Nomad SERVICE BULLETIN

FUSELAGE — STUB FIN — REPLACEMENT OF PLATE PN 1D/N-12-57 (MOD N759)

ANMD-53-13

Figure 1 Stub Fin Side Skin Deriveting Pattern

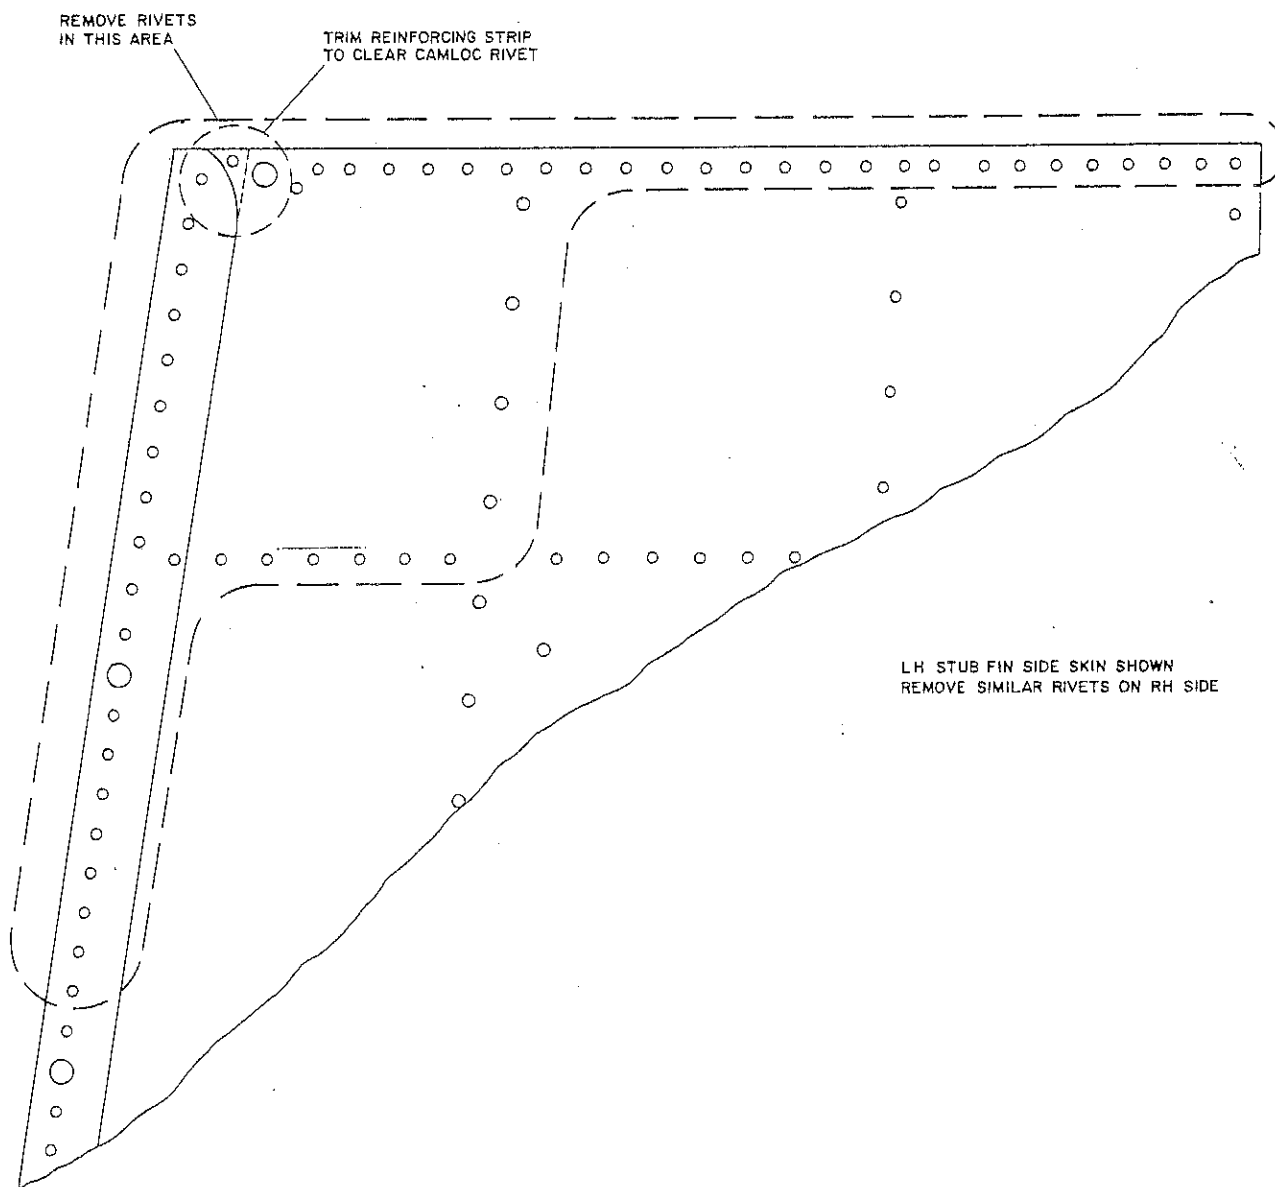
- Drill heads of rivets only and gently chisel off.
 - Where possible, separate parts and remove rivet tails using a punch on a workbench.
 - For in situ removal, support area adjacent to rivet tail with suitable bucking bar and remove rivet tails using a punch.
 - Note the rivet types used.
- H. To allow removal of forward top Camlocs, carefully derivet LH and RH stub fin skins as indicated in Figure 1.
 - I. Carefully ease back stub fin side skins and derivet forward top Camlocs. Remove Camlocs and packer, retain for refitting.

Figure 2 Exploded View of Rib Assembly

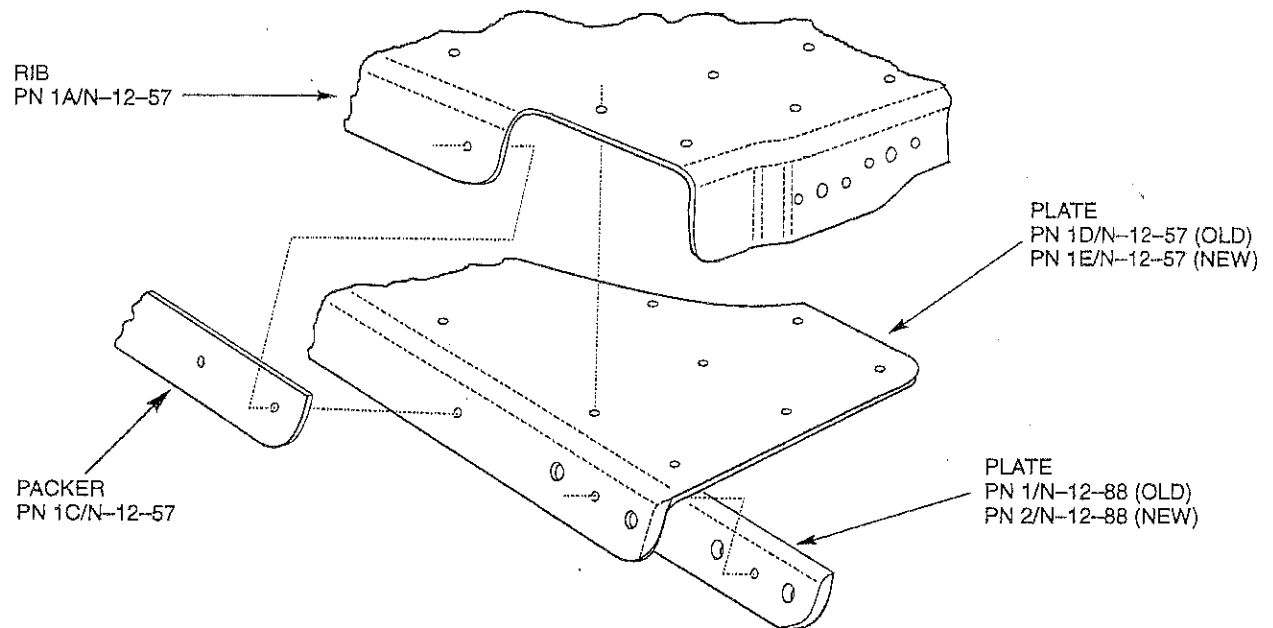
Inspection of a number of aircraft has revealed the presence of cracks along the forward flange of Plate PN 1D/N-12-57 fitted to the top of the stub fin as part of Rib WL 138.87. This cracking is obscured by Plate 1/N-12-88 and is a result of fretting/fatigue of the plate.

Plate PN 1D/N-12-57 is removed and replaced with a new steel Plate PN 1E/N-12-57.

- J. Refer to Figure 2 for identification of parts. Carefully derivet Rib Assembly WL 138.87 complete with Rib PN 1A/N-12-57, Packer PN 1C/N-12-57, Plate PN 1D/N-12-57, Plate PN 1/N-12-88 and Fin Attachment Channel Assembly. Remove rib assembly.

- Identify and retain for later use all items except Plates PN 1D/N-12-57 and PN 1/N-12-88.
 - Retain the four bolts, taking careful note of which bolt was in each hole.
- K. On a workbench derivet and separate Plate PN 1D/N-12-57, Packer PN 1C/N-12-57 and Plate PN 1/N-12-88. Discard Plates PN 1D/N-12-57 and PN 1/N-12-88.
 - L. Clean area of metal swarf, remove all rivet tails and inspect all holes for serviceability or elongation.
 - M. Carefully dress the radius on new Plate PN 2/N-12-88 so that it is a neat fit into radius of new Plate PN 1E/N-12-57. Coat bare metal surfaces with zinc chromate primer.

- O. Assemble new Plate PN 1E/N-12-57 and Packer PN 1C/N-12-57 and clamp in position. Ensure that Plate PN 1E/N-12-57 is centrally located on rib and in firm contact with spar boom angles in each forward corner.

- P. Back drill three centre holes on forward end of rib and pin.
- Q. Using a drill bush with an outside diameter to match the diameter of existing holes and 3.5mm inside diameter, back drill the fin/horizontal stabiliser attachment bracket bolt holes in Plate PN 1E/N-12-57.

- Illustration of the fin/horizontal stabiliser attachment bracket is shown in SB NMD-53-5.
 - Take care not to elongate the bolt holes during back drilling.
 - For the outboard bolt hole a minimum hole centre to plate outboard edge distance of 0.185 in is acceptable.
- R. Back drill several holes in Plate 1E/N-12-57 from top of rib, pin and then back drill remaining holes and pin.
- S. Remove rib assembly, plate and packer. Carefully open up inboard and outboard bolt holes drilled in step Q in accordance with the bolt taken from that hole in step J, as follows:
